Notice is hereby given according to State Statutes that the SITE REVIEW COMMITTEE of the Village of Hobart will meet on **Thursday May 28th 2026**, at 5:30 P.M. at the Village Office (2990 South Pine Tree Road). NOTICE OF POSTING: Posted May 22nd 2026, at the Hobart Village Office and on the village website.

MEETING NOTICE – SITE REVIEW COMMITTEE

RE: 1130 Orlando Dr., HB-332-3-1; 16,945 SF Indoor Riding Arena/Barn w/ Associated site Improvements

ISSUE: Discussion and action to consider a new 16,945 SF Indoor Riding Arena/Barn w/ Associated site Improvements

Overall Site Plan
 Exceptional Equestrians - Barn Addition
 1130 Orlando Drive
 Village of Hobart, WI

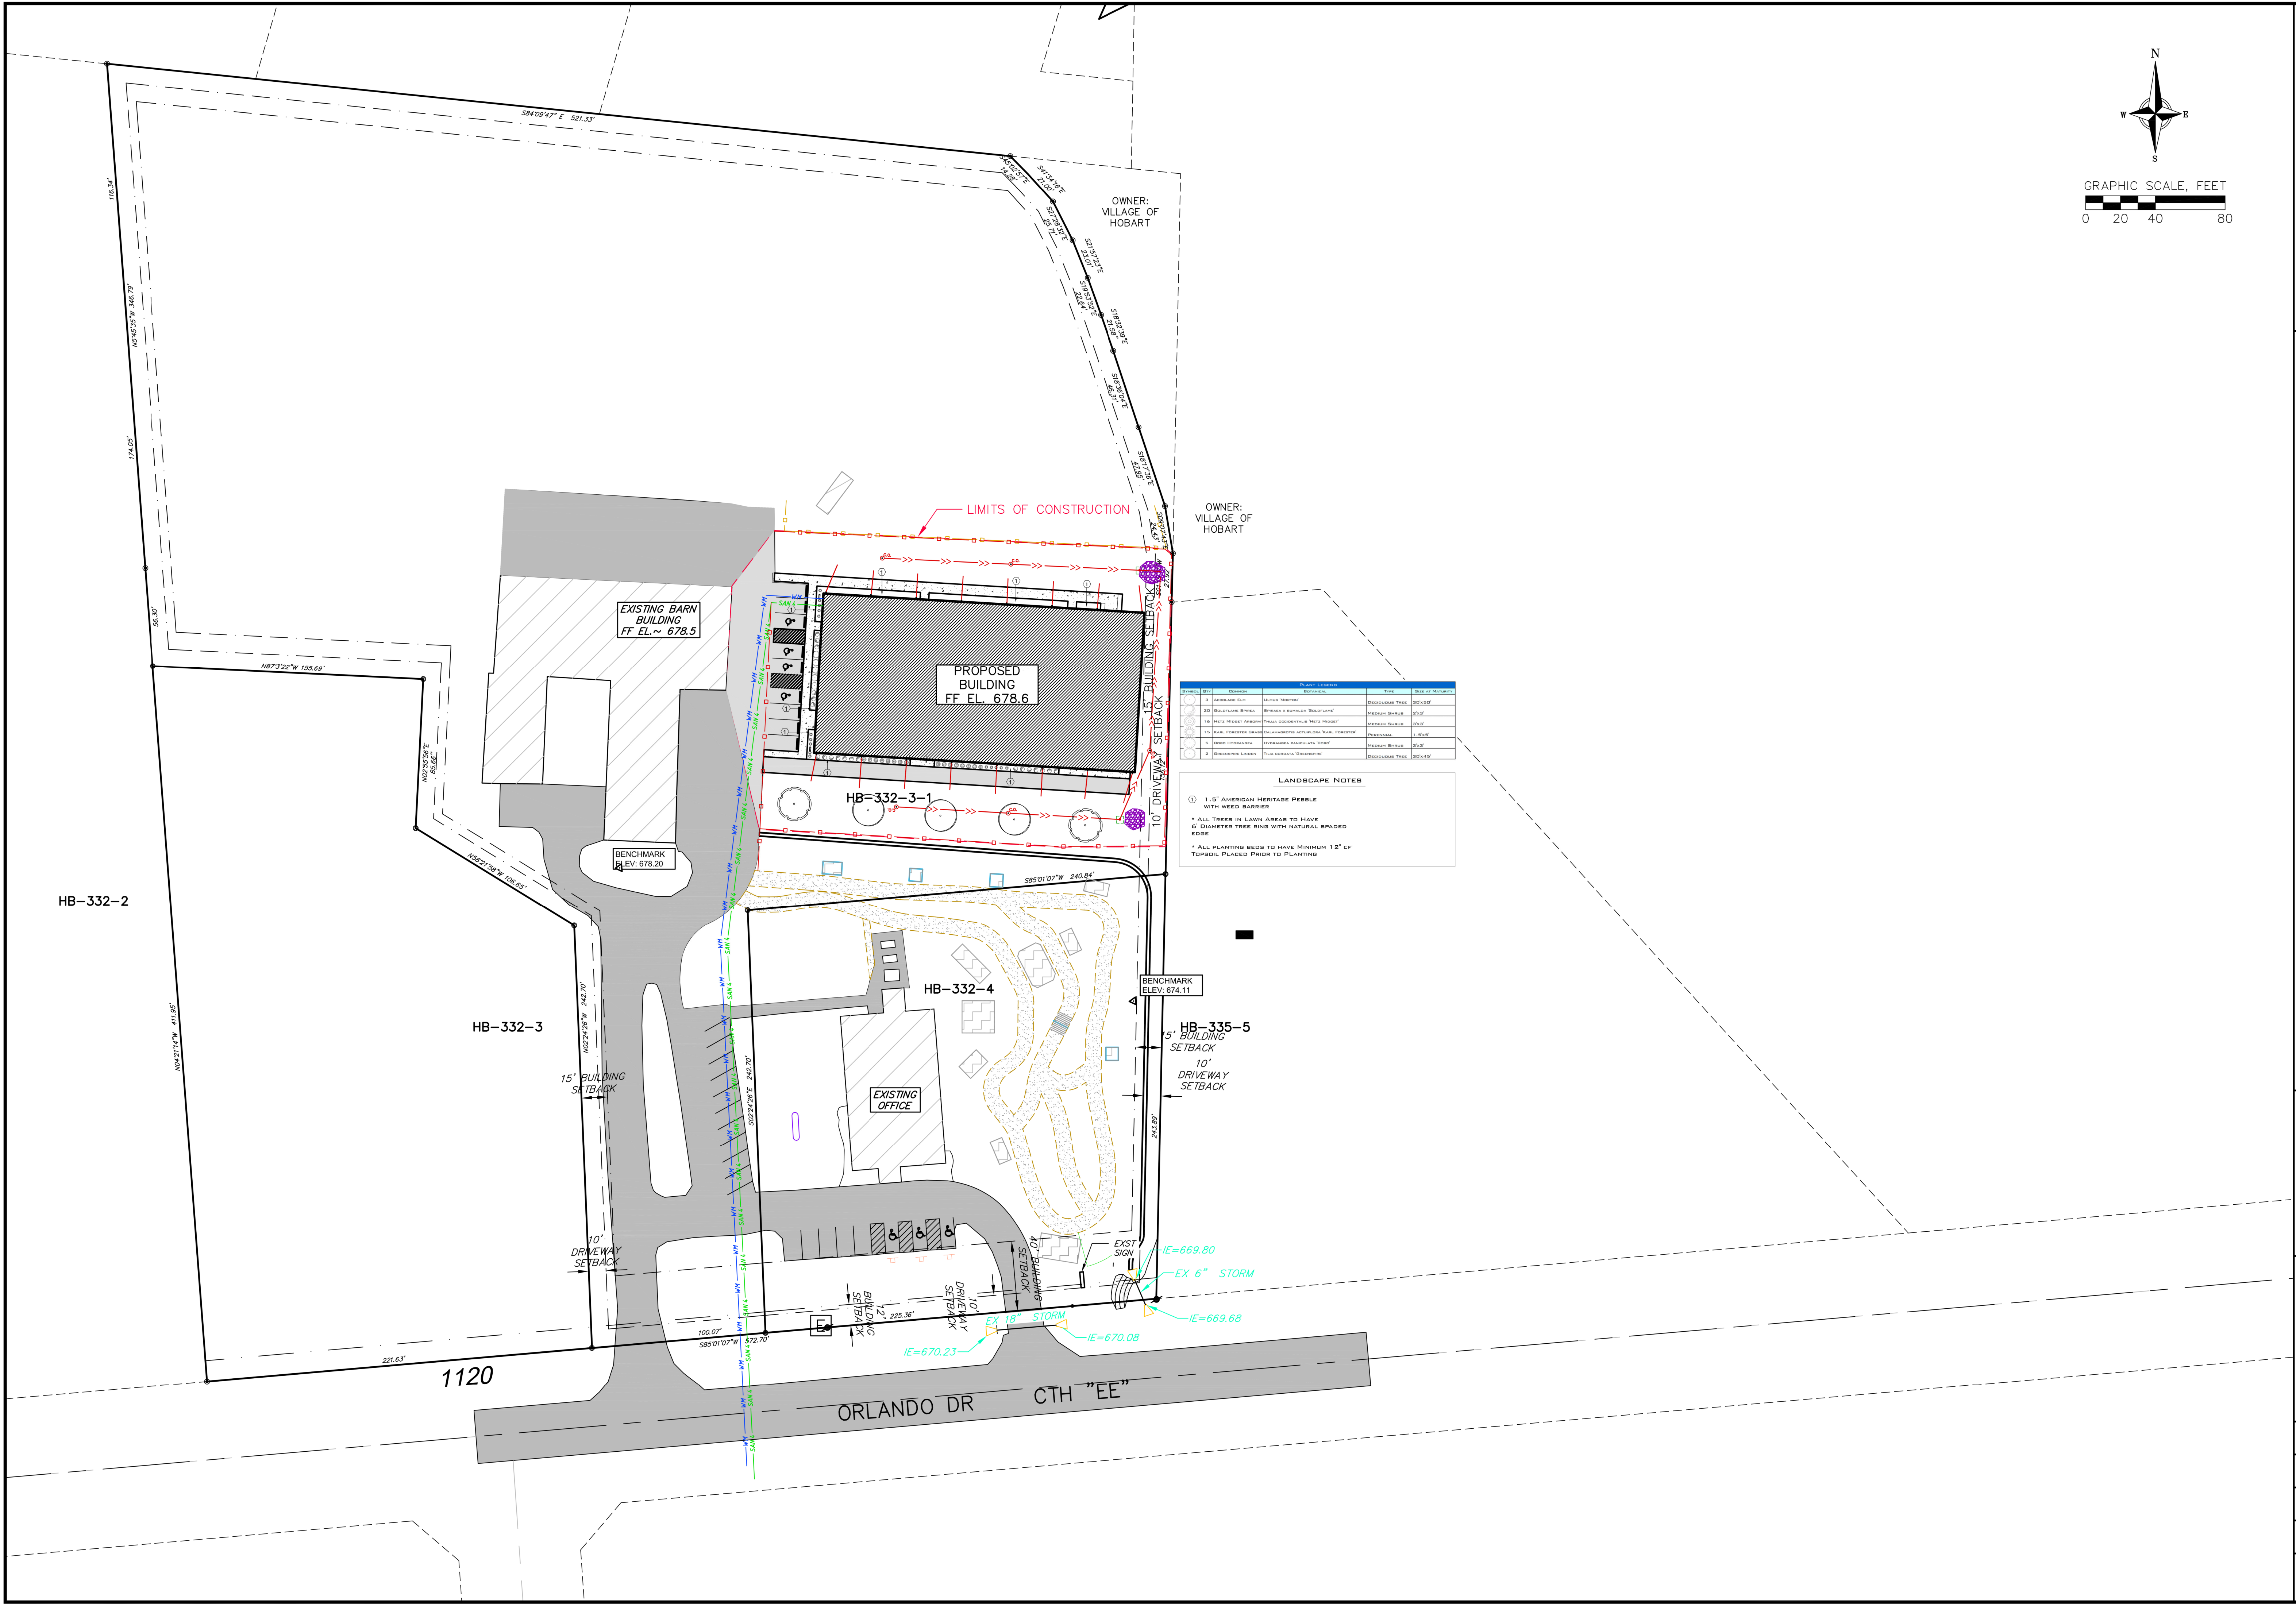
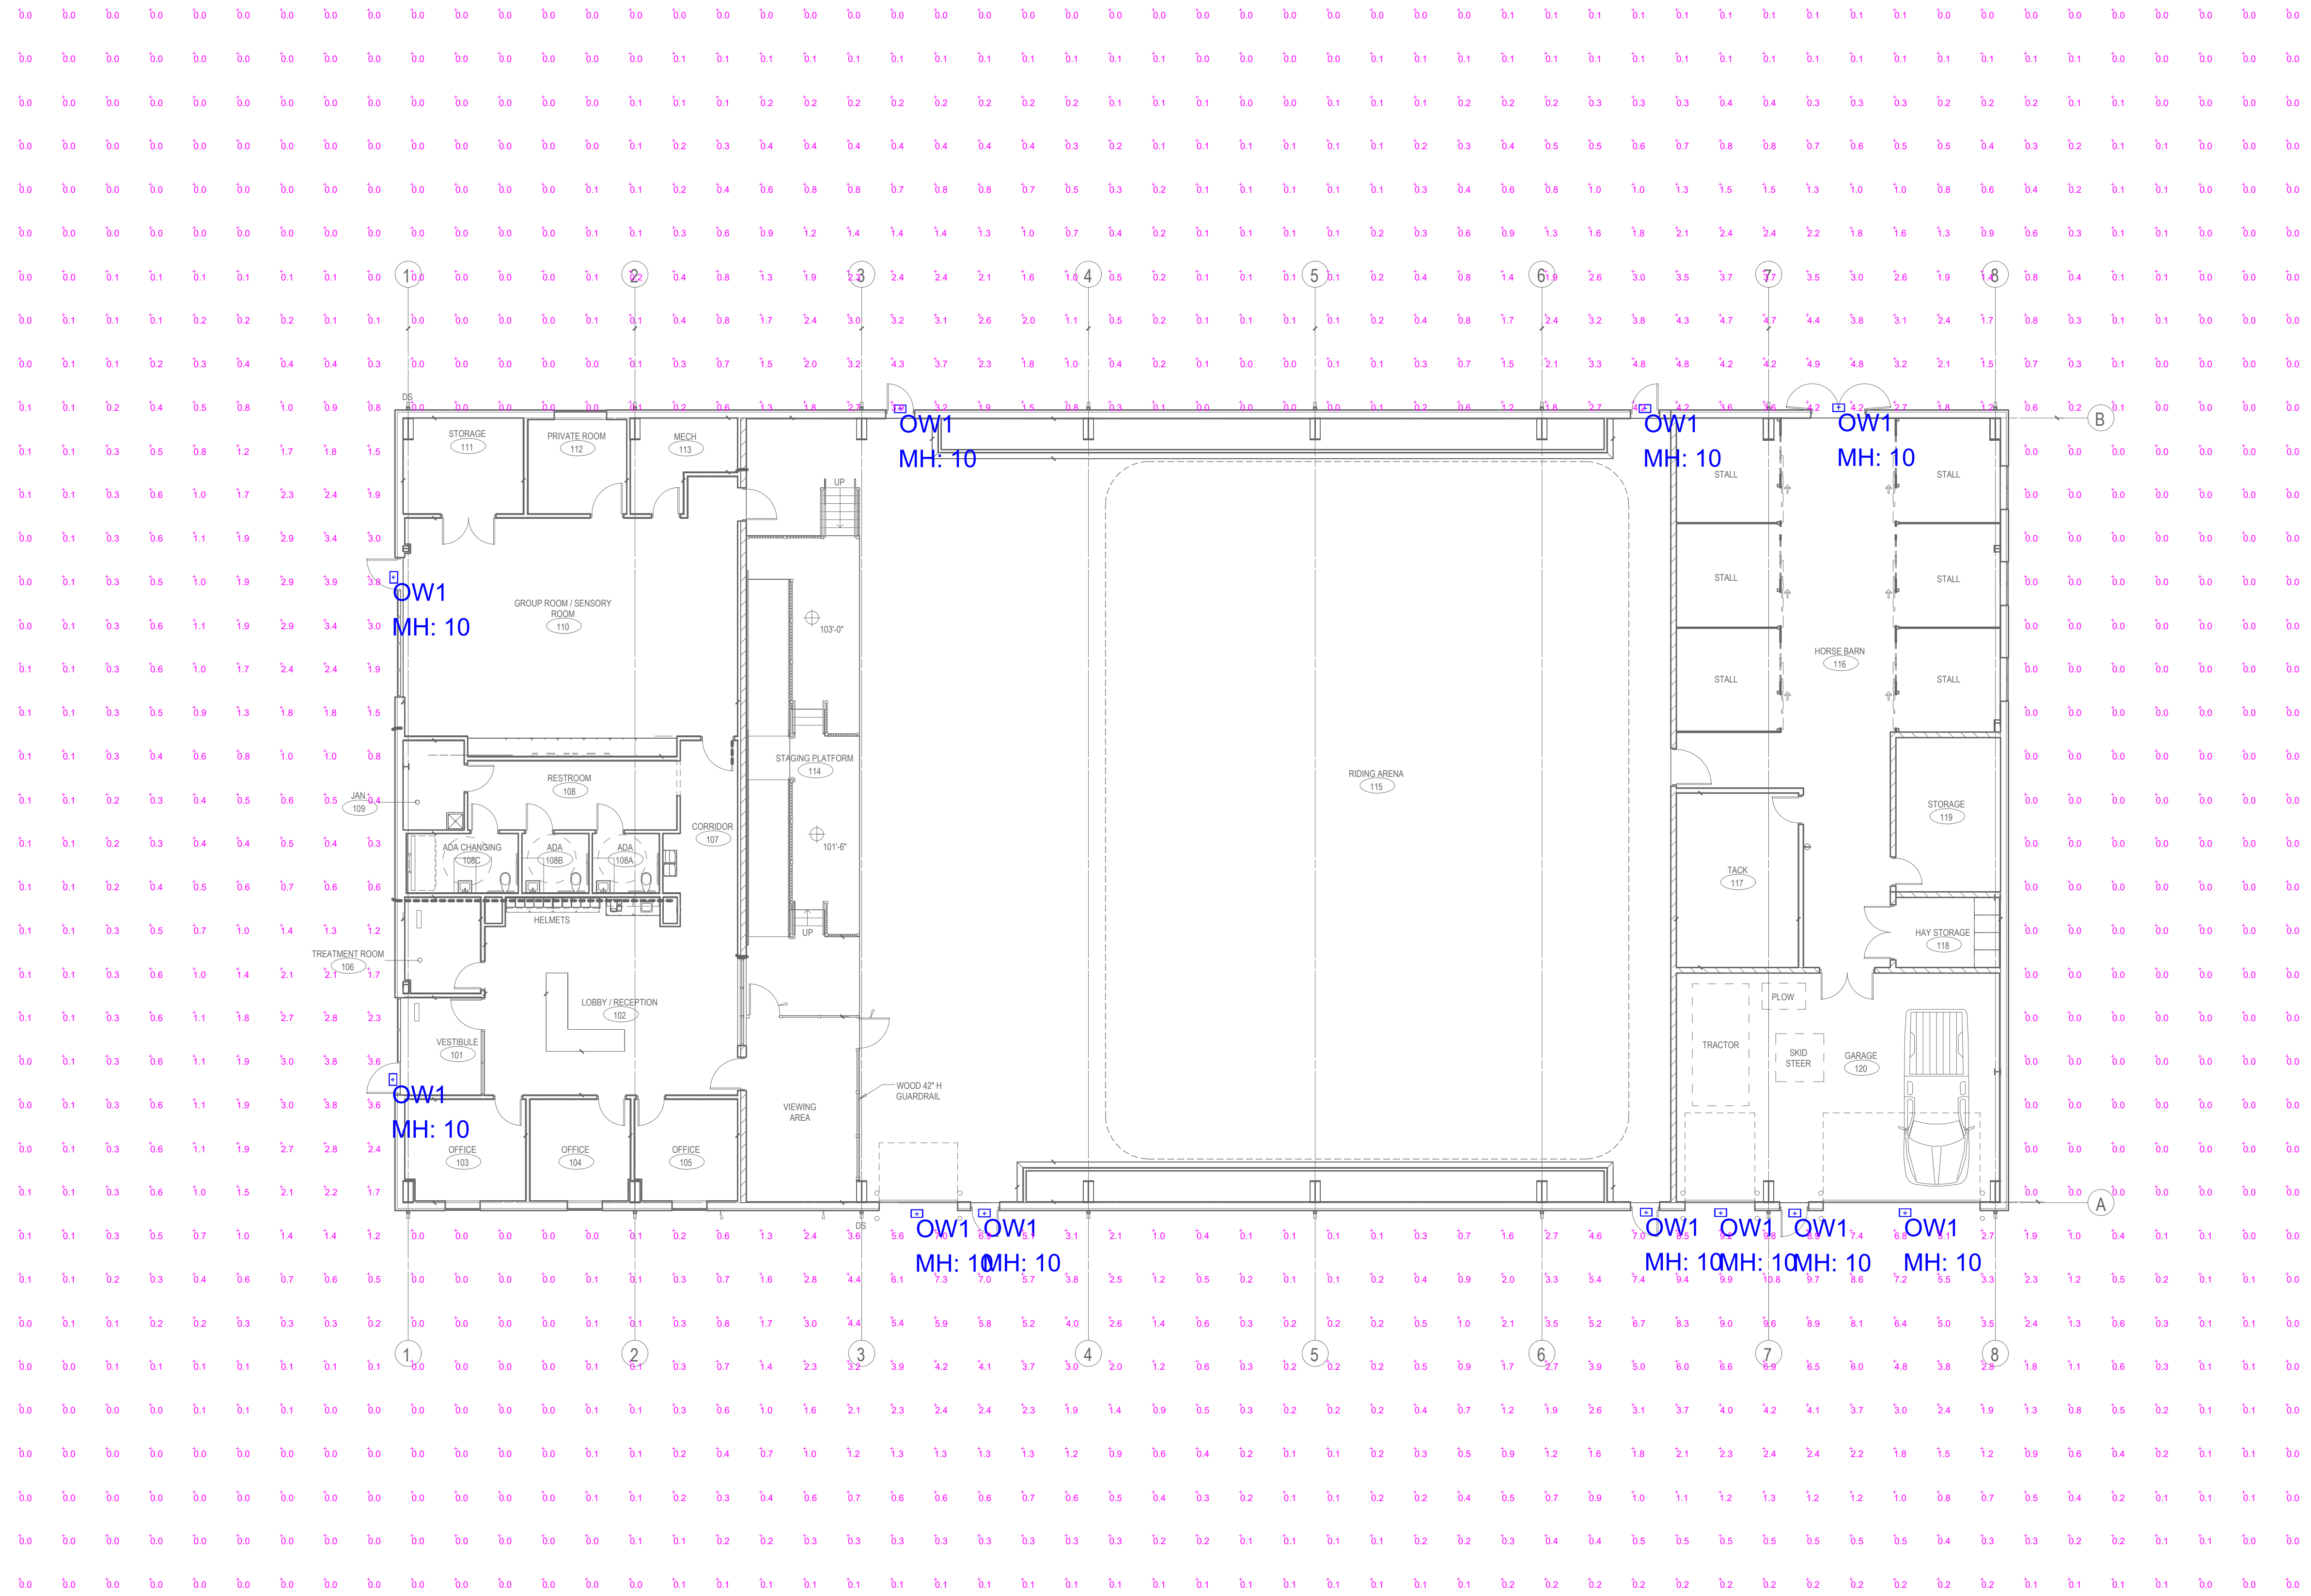
Section 3, Landscaping Plan: The submitted landscape plan notes foundation plantings along the west (main entrance) and south building elevations. Additionally, there are 5 proposed trees in the landscape area south of the proposed building that will be between the building and Orlando Dr.

Section 4, Lighting: Building mounted lighting will consist of 11 architectural wall sconces that direct the lighting downward.

Section 5, Signage: The signage noted on the building elevations exceeds the limits of the Village Sign Code. Therefore, any proposed signage shall be required to be submitted for approval at a later SRC meeting prior to installation.

1. Lock box location(s) shall be approved by the Village Fire Chief
2. Any and all mechanical equipment shall be screened from view with materials to match those of the principal structure or with landscaping, and all exterior exhaust/intake vents shall be colored to blend with the principal structure.
3. No lighting shall create a glare to adjoining properties or public roadways. Only the proposed wall packs are part of this lighting approval. Any other future lighting will require review and approval by the SRC.
4. Any proposed signage shall be required to be submitted for approval at a later SRC meeting prior to installation.
5. Storm water plans shall be approved by the Village Engineer.
